AGENDA
PLANNING AND ZONING COMMISSION MEETING
CITY OF CREVE COEUR, MISSOURI
MONDAY, DECEMBER 4, 2017
6:30 PM

**APPLICATION TO PLANNING AND ZONING COMMISSION
#16-031 FOR THE REZONING, CONDITIONAL USE PERMIT, AND SITE
DEVELOPMENT PLAN AND BOUNDARY ADJUSTMENT APPROVAL OF A
MOBIL ON THE RUN CONVENIENCE STORE WITH GAS PUMPS AND
BRITWORX CAR WASH FACILITY LOCATED AT 11109-11141 OLIVE
BOULEVARD & 11100-11114 OAK LAKE COURT, CURRENTLY ZONED GC
GENERAL COMMERCIAL AND C SINGLE FAMILY RESIDENTIAL**

REPORT PREPARED BY: Jason Jaggi, AICP, Director of Community Development; Whitney Kelly, AICP, City Planner
DATE: 12/1/2017
ATTACHMENTS: Applicant's Revised Materials received November 27, 2017
Draft Ordinance
Public Comments received

Olive & Schulte
 Enviromental Noise Study
 November 7th, 2016

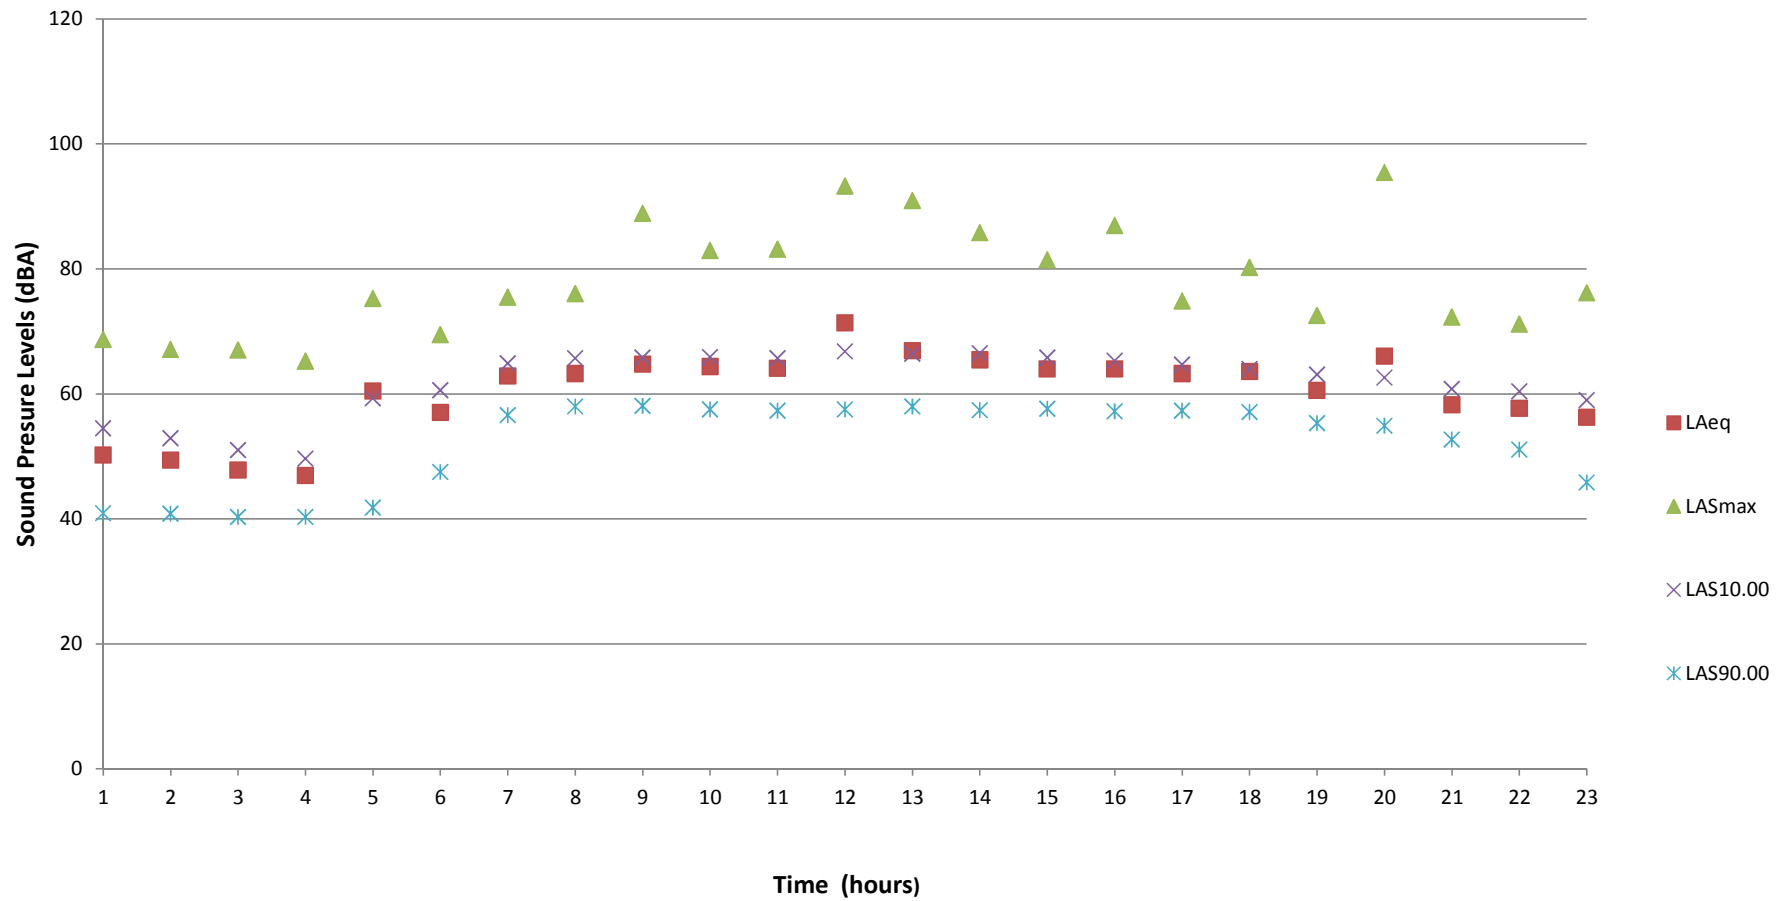
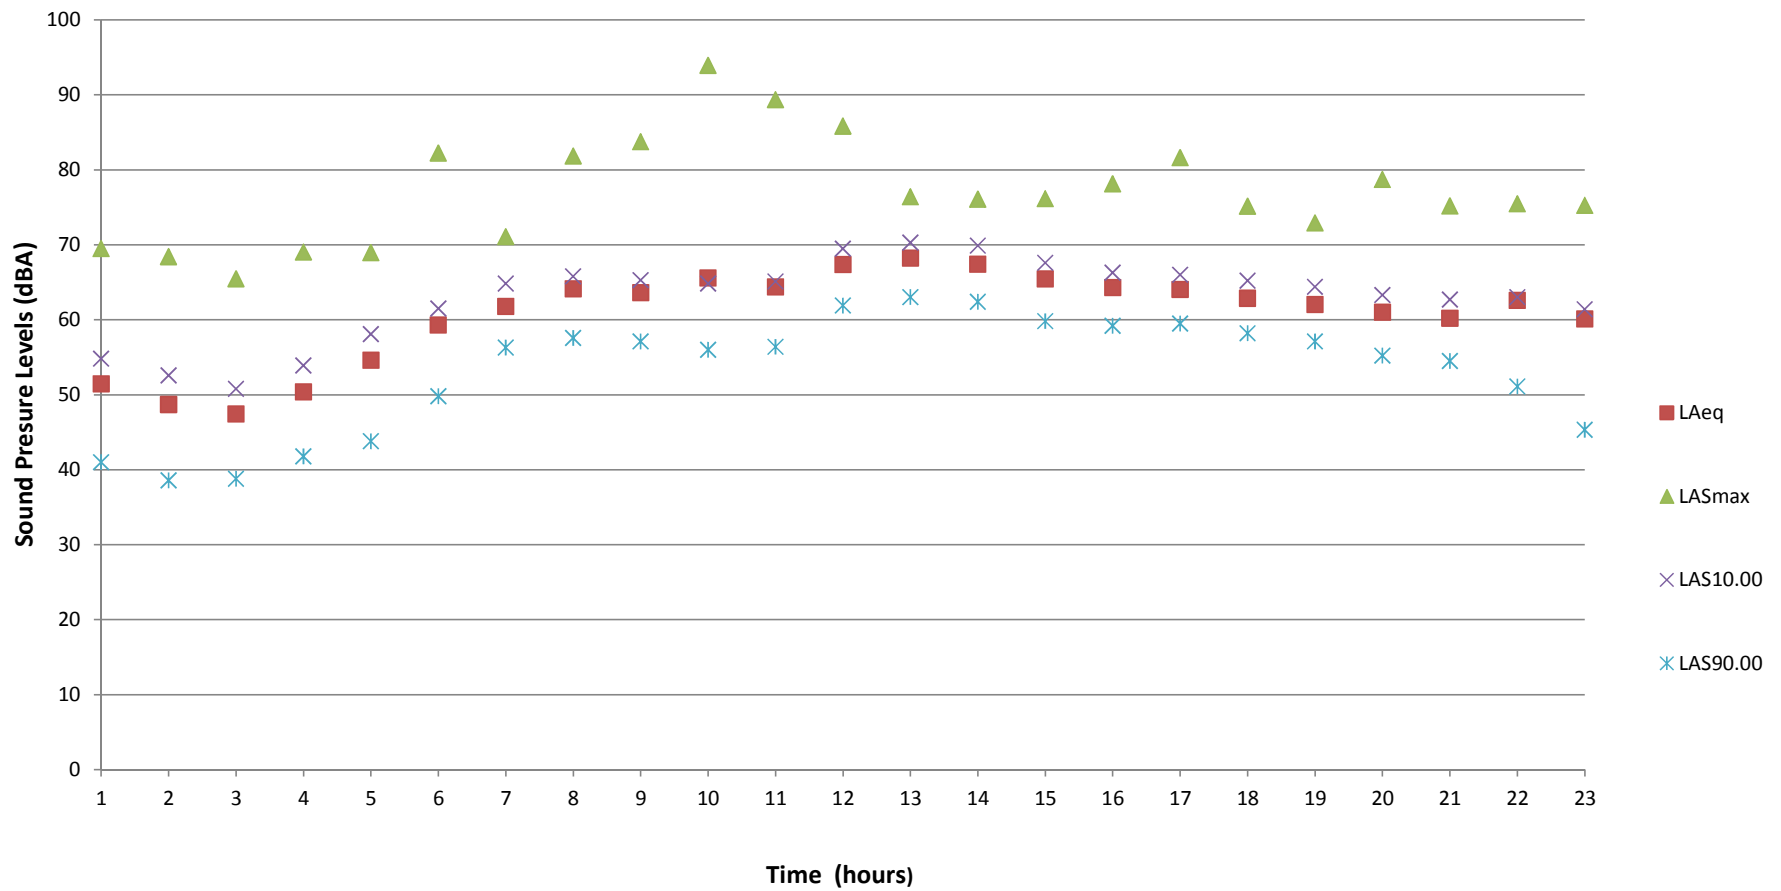
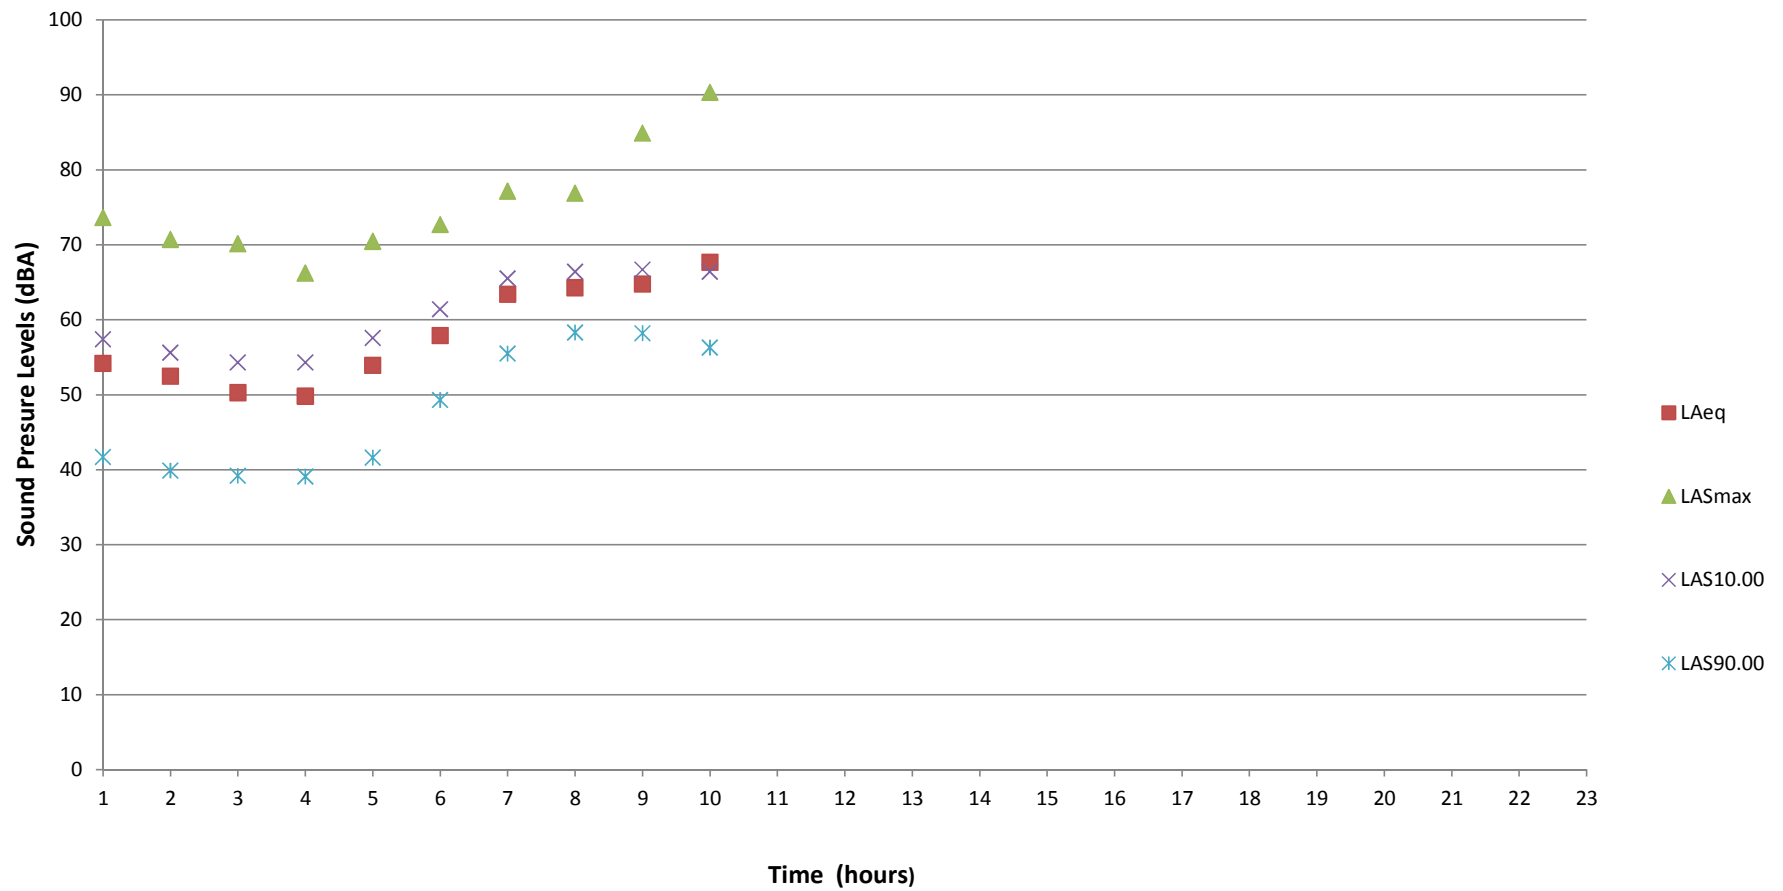
Figure 19: Graphic of the Environment Noise Study from the Applicant's Acoustic Study

Painted Band 36" Tall

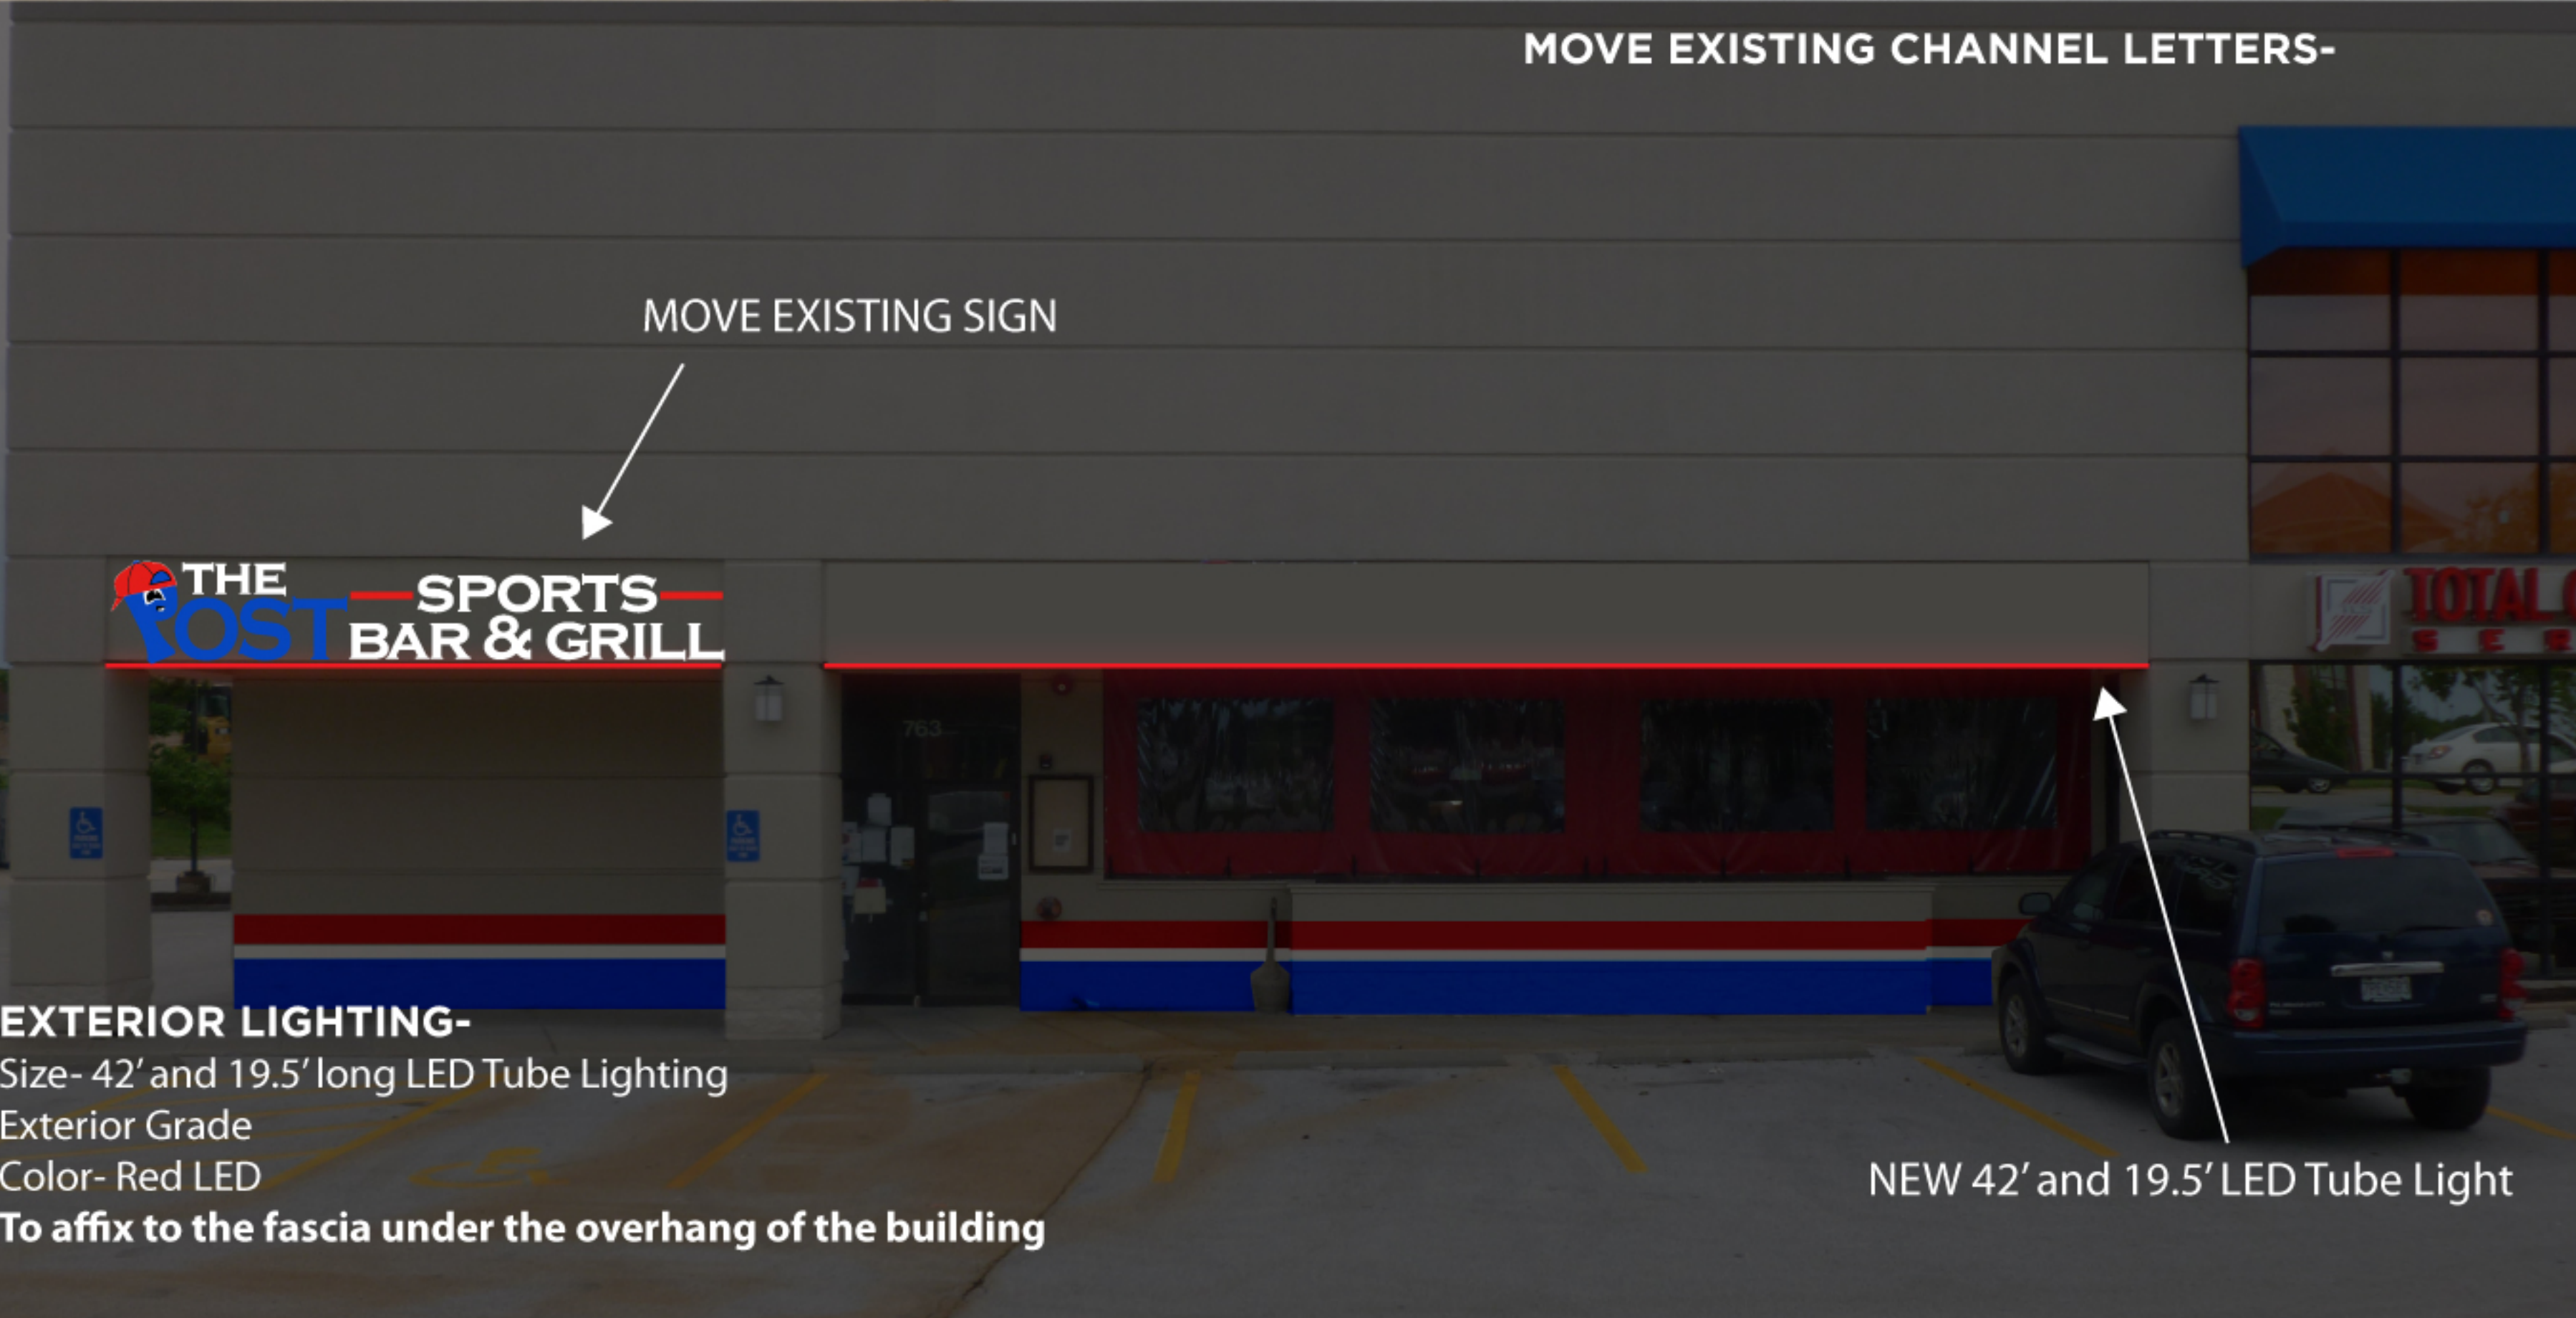
There are 2 visibility issues the business needs to resolve. The first one is during daylight hours when the entire building from the Olive perspective appears to be not be open and operating even with the building sign. The facade is plain with no color to attract the lucrative lunch crowd traveling westbound on Olive. The lunch crowd is vital for any restaurant operating in that area of Creve Coeur. We propose to paint on the facade 3 colors matching the Post's color branding. Revenue from year 2014 to 2017 projection indicates a revenue loss of 9%. We believe a substantial portion of the sales decrease (and subsequent decrease in sales tax revenue) is attributed to the poor visibility, lack of attraction and growing impediment of the trees on Old Ballas.

The other visibility issue is during night hours where the illuminated sign is partially blocked by the trees as well competing with the downward slope of the property. Our solution to this problem would be to move the existing sign to another location on the same side of the building at a height that reduces the visibility issues caused by the low façade and trees. We have reached out to the landlord of the building to ensure that this would not be a problem with them considering the higher portion of the façade is the outside wall of another store. The landlord has said that it would not be a problem and they just need to see a rendering in order to see what the sign would look like so they can officially sign off on the permission.
